5TH & LENORA

PROJECT INFORMATION

ADDRESS: 5TH AND LENORA
DPD PROJECT #: 3026266

EDG SUMMARY

GUIDANCE FROM EDG **A**

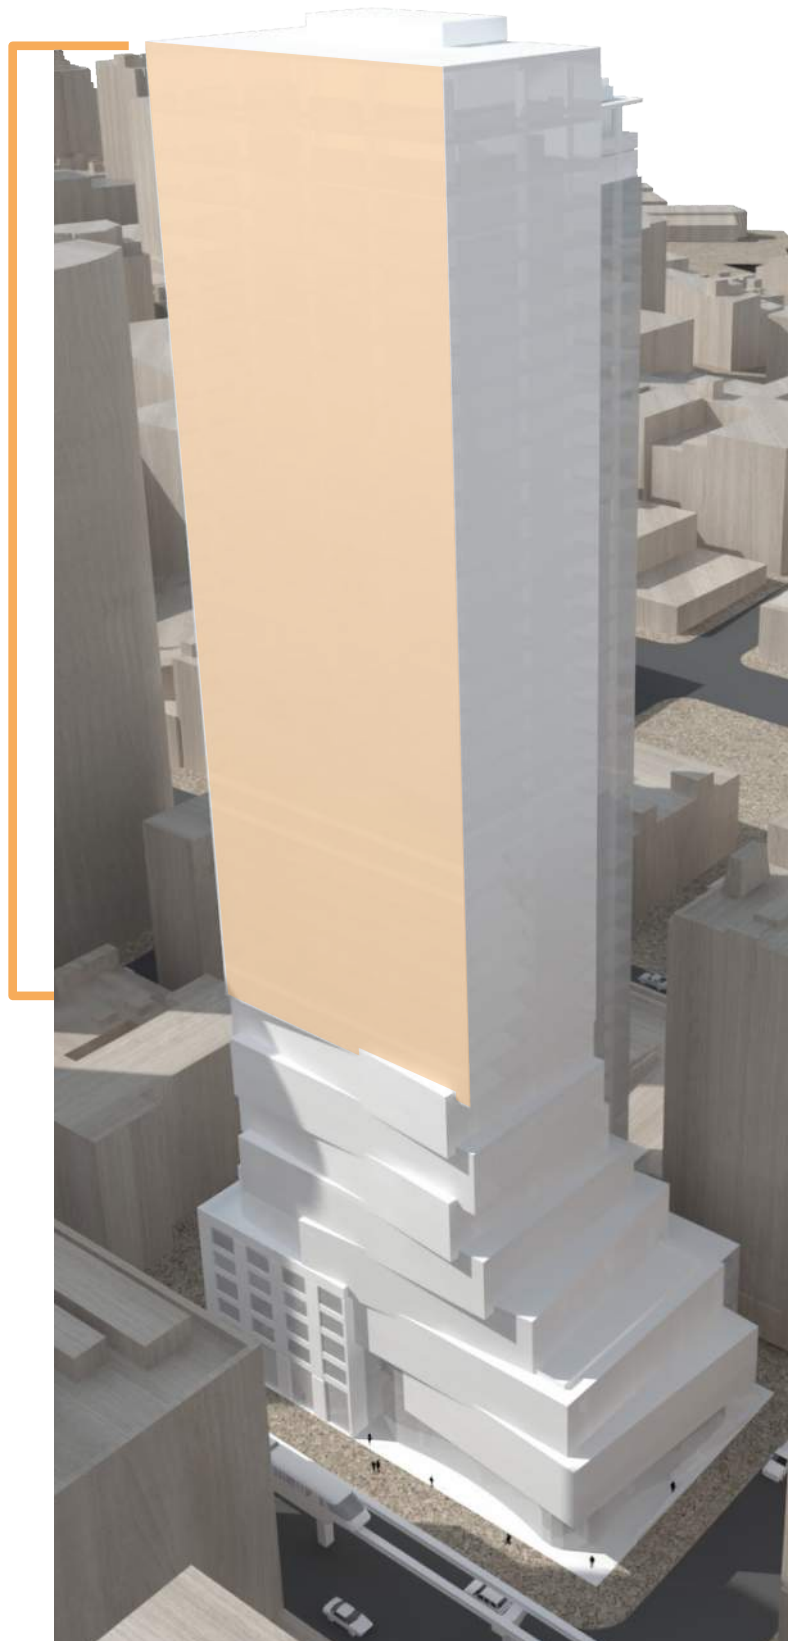
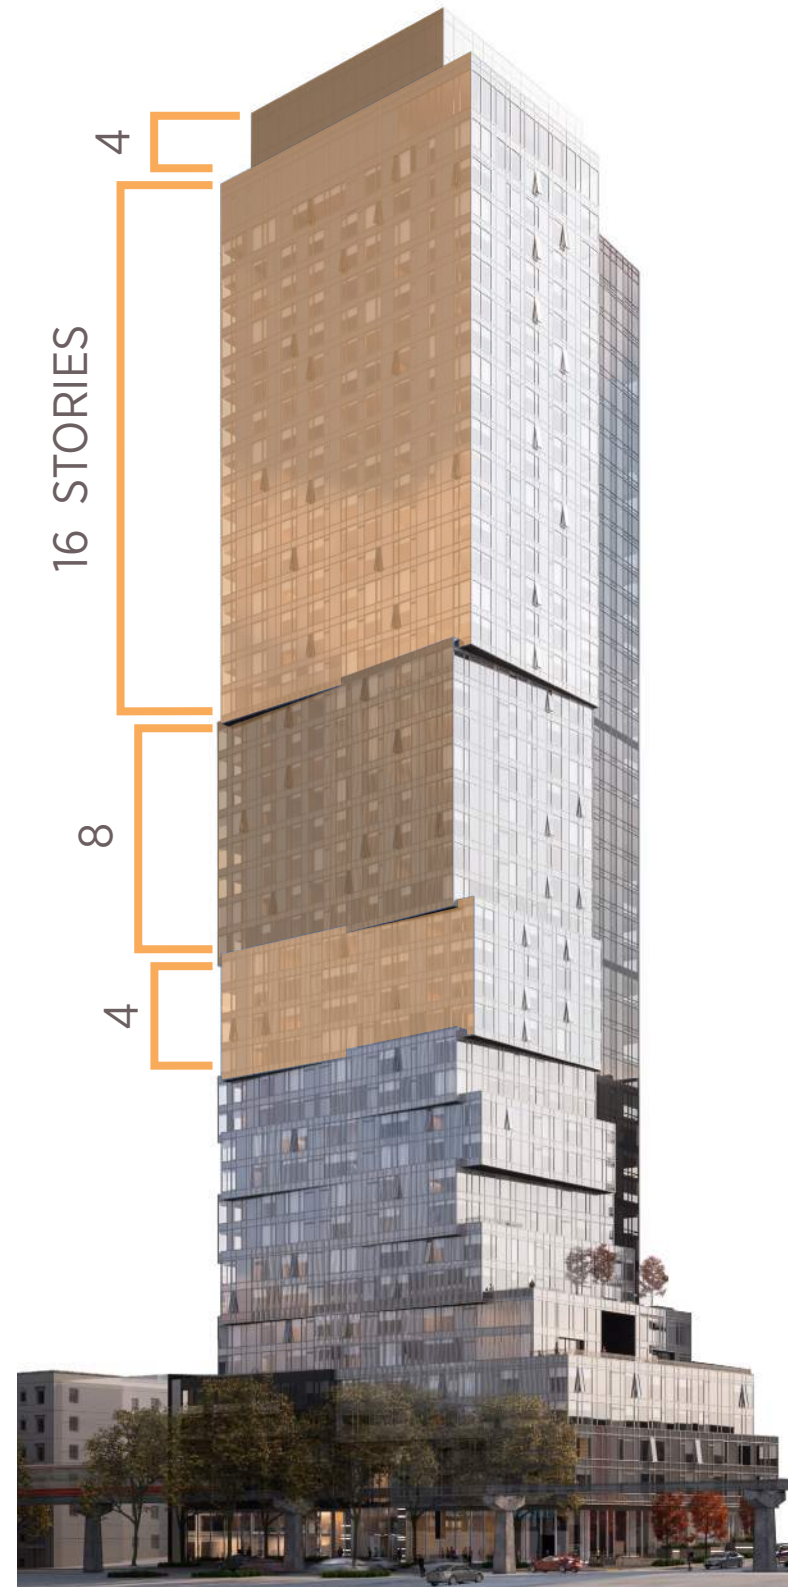
a. While the Board strongly supported the form of the lower 15 floors of Option 3, they unanimously agreed the tower abruptly changes to a cubic extrusion at level 16 [60] and it therefore compromises a unified design. The Board agreed a uniform vertical shaft of tower was not related to the design energy of the podium, and recommended integration strategies such as: rotating 2-floor groups in select other locations on the upper tower, and/or rotating a sizable amount of the tower top, to reiterate the rotating form at the skyline scale. The Board was also concerned about the long, unmodulated east wall of the tower, which reinforces the abrupt tower form (see departure # 1). (A2, B1, B4-2)

A Cohesion of upper tower design with lower modulation (A2, B1, B4.2)

The new modulation breaks the mass of the tower and the upper east face of the building.

EAST ELEVATION

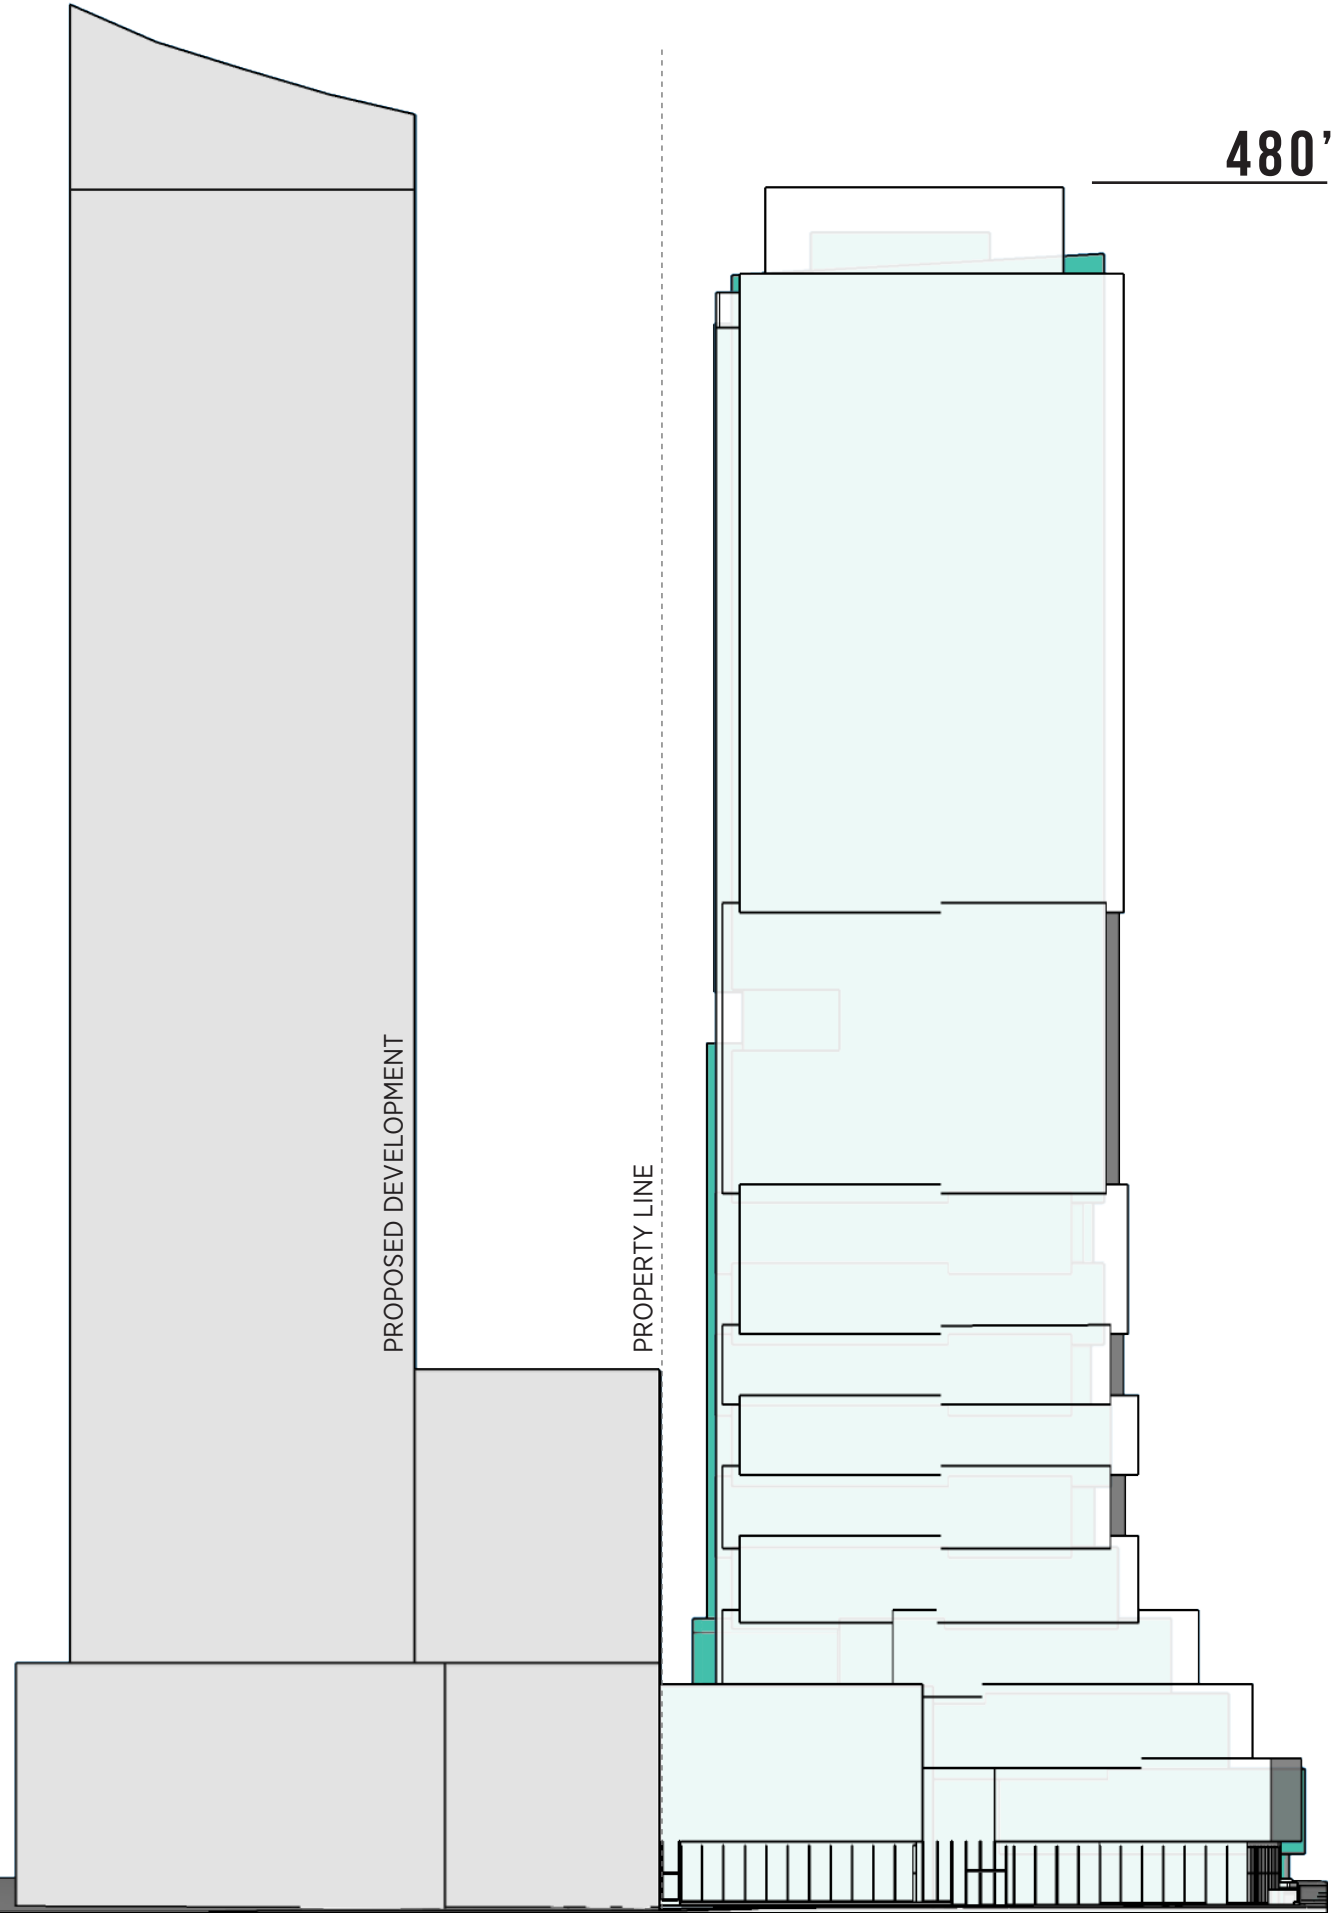
-  EDG SUPPORTED MASSING
12' From Property Line
-  PROPOSED MASSING
16' From Property Line

GUIDANCE FROM EDG **B**

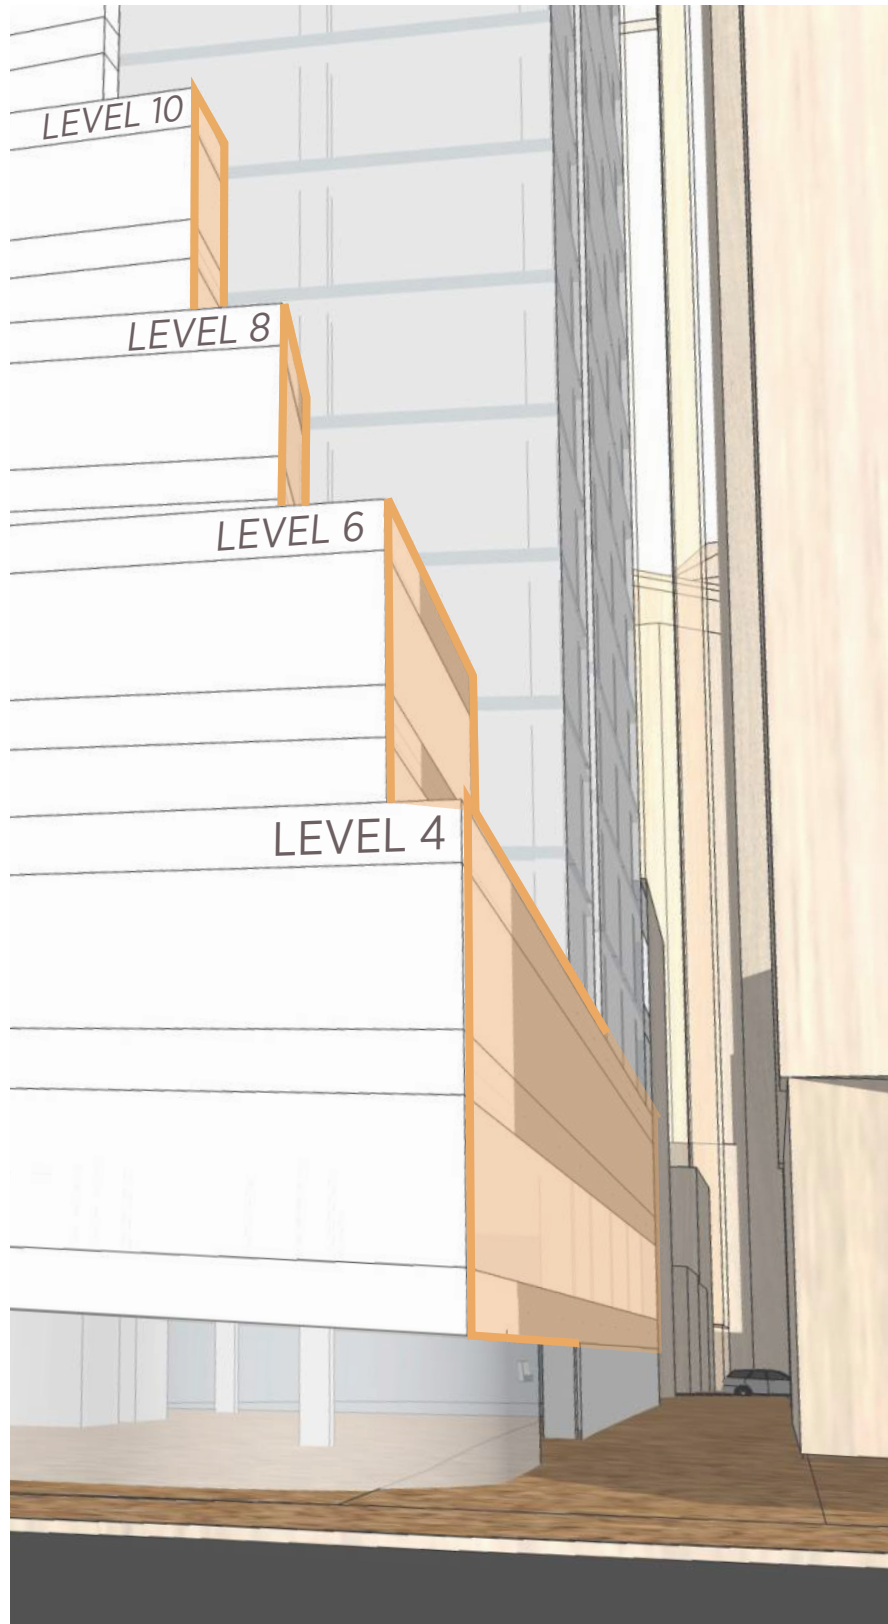
b. The Board tentatively supported the tower mass being broken into 2 offset volumes [67; typical tower plan] but agreed the north and east massing refinements described above are a priority and the key design test. Pending resolution of the tower-to-podium cohesiveness cited above, the rotating tray strategies might need to carry around to the entire tower, especially on the visible west and south elevations. (B4-2)

B Carry rotating trays around to the west side of the tower (B4.II)

The modulation from the east massing is articulated in the west facade.

GUIDANCE FROM EDG **C**

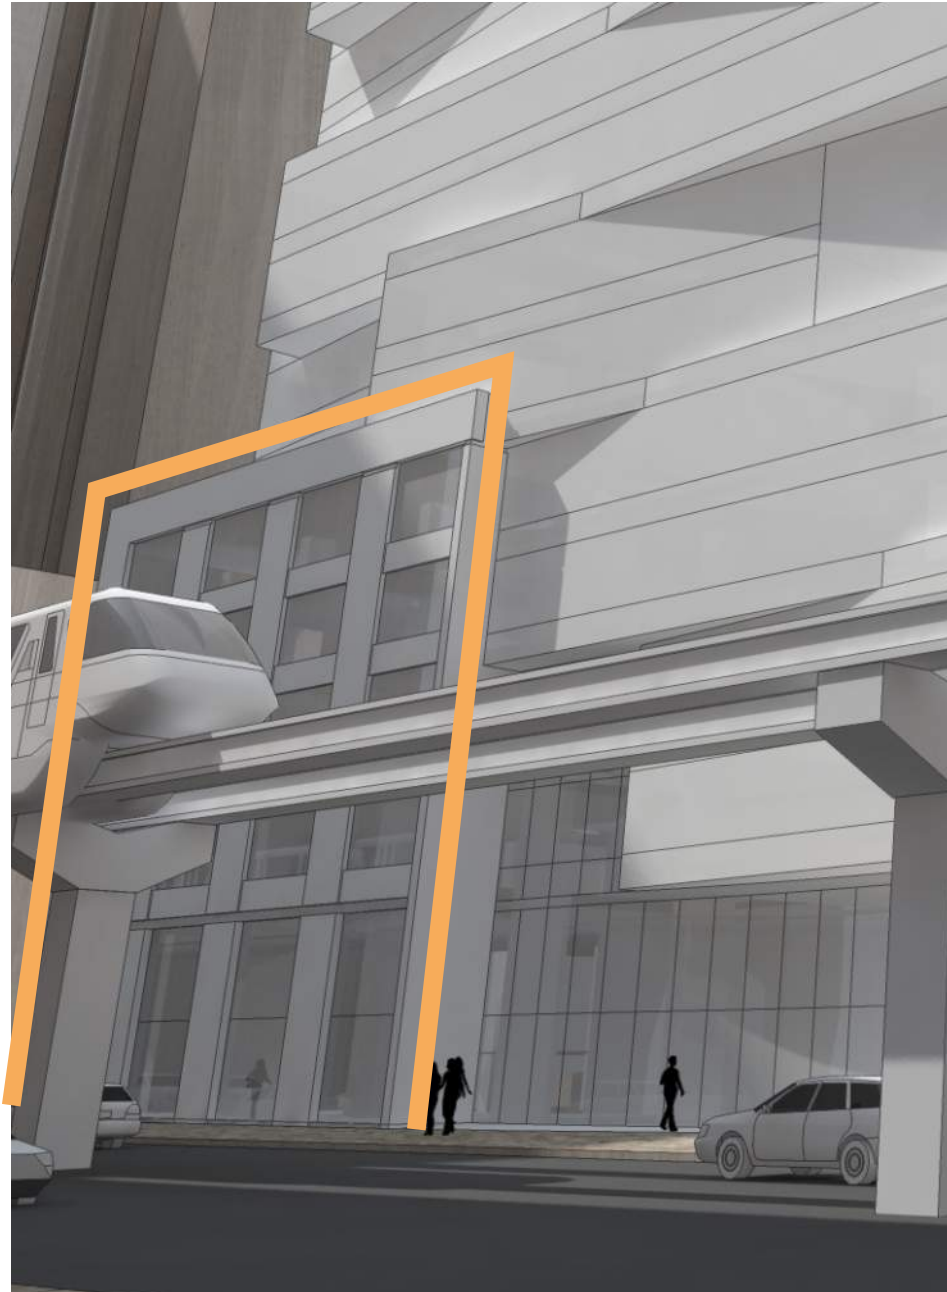
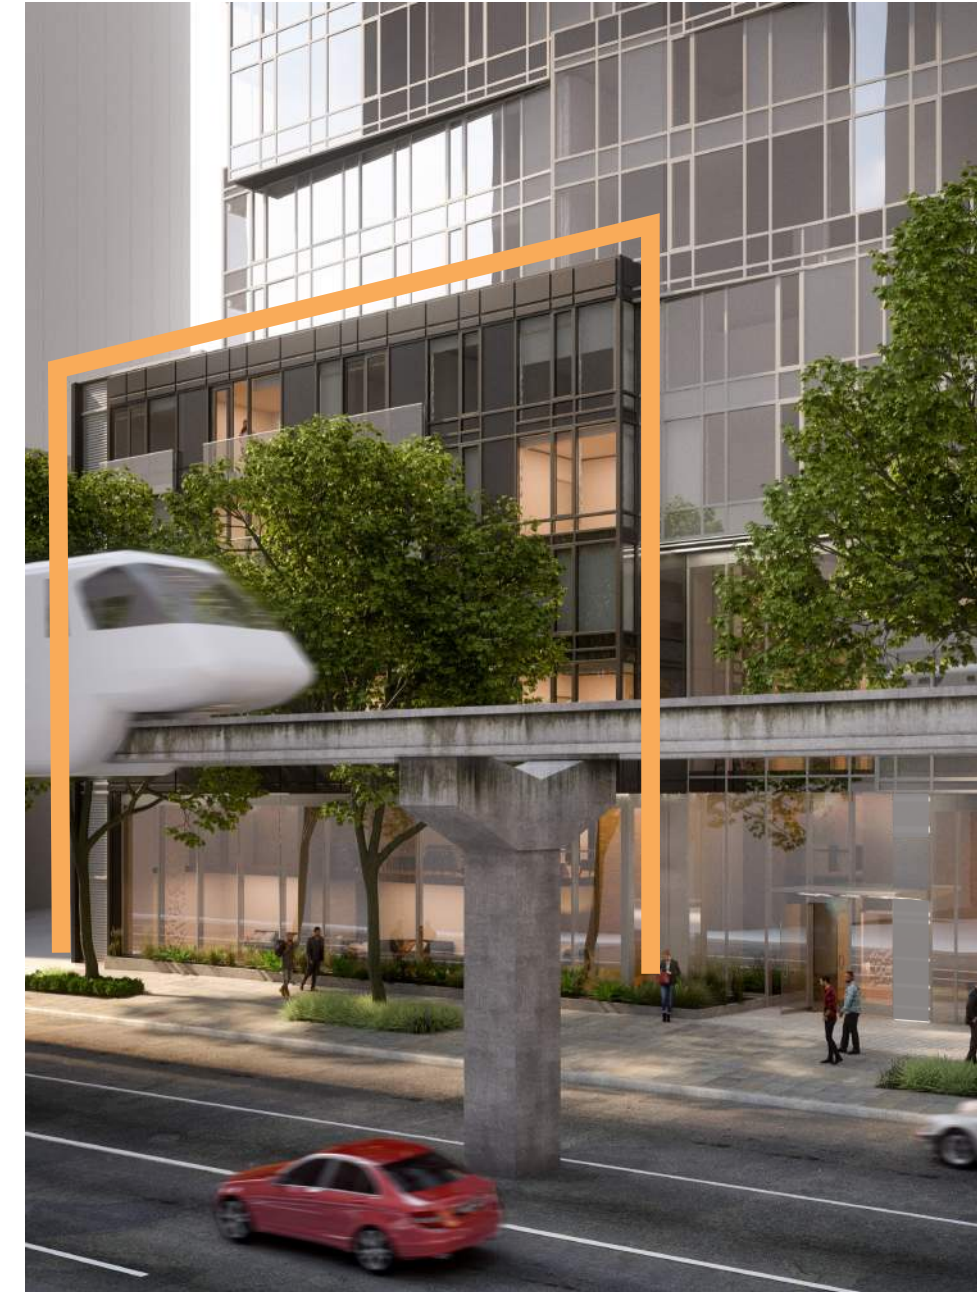
a. The Board supported the podium along 5th being expressed as 2 distinct forms, with the primary entrance at the crease [77], but agreed the south form should not be so traditional as shown [69, 71] or appear grafted onto the progressive forms of the majority of the podium. While not employing the rotated theme, or 'glass box' language of the corner, this 5-story element should display transparency, pedestrian scale and a tall proportion along the mid-block. (C1; C2)

C 5-story element should display transparency, pedestrian scale, and a tall proportion

Transparency and plantings at the street level preserve pedestrian scale while Juliet balconies maintain a human scale above the street.

GUIDANCE FROM EDG **D**

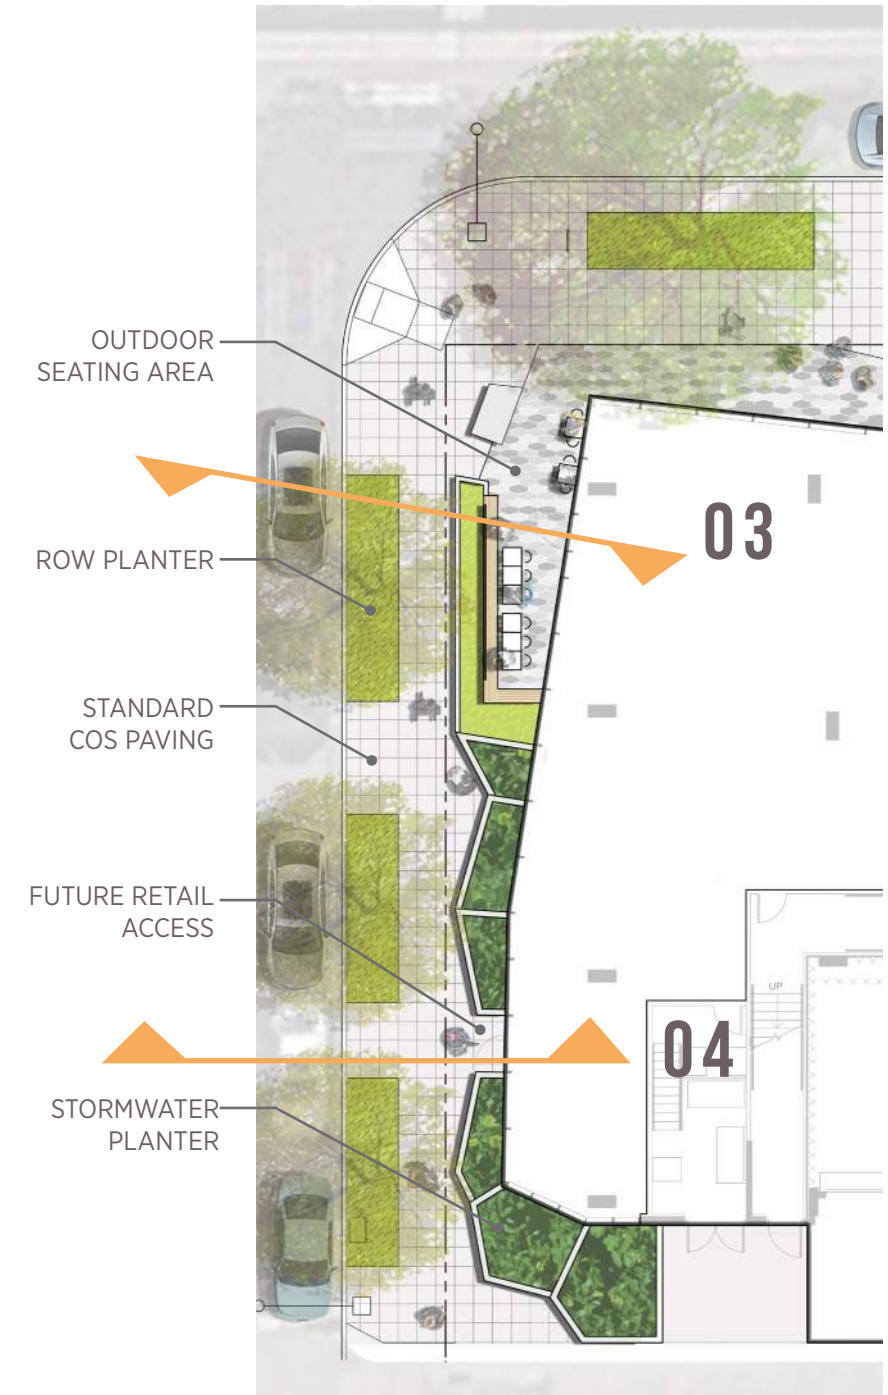
d. The Board supported a stepped, planter/rainwater element at the alley corner as shown on pg 63 and 70 (but ensuring good pedestrian sight lines), but agreed the planter along the Lenora storefront and the deep café moat [76/77] created a privatized zone and too many vertical pedestrian barriers between the sidewalk and the Lenora storefront. (D1-1.d, D1-1.b)

The Board recommended reducing or eliminating these elements to maintain a gently sloped sidewalk/setback near the corner (without guardrails or recesses), and sloping the sidewalk along a raised sill of storefront along Lenora. The Board supported shortening the planter portion adjacent to the street wall. Even if retail doors are near the corner, a 5 ft slope over the 106ft length of Lenora should not mandate a continuous privatized, buffer zone at this important storefront location. (A1-III; C1)

D Reducing sidewalk barriers to increase activation and connection to sidewalk (A1.III, C1)

The proposed design places a low planter between the seating area and the side walk. The height of the storm water planters has been reduced to be as low as possible and still meet storm water requirements.
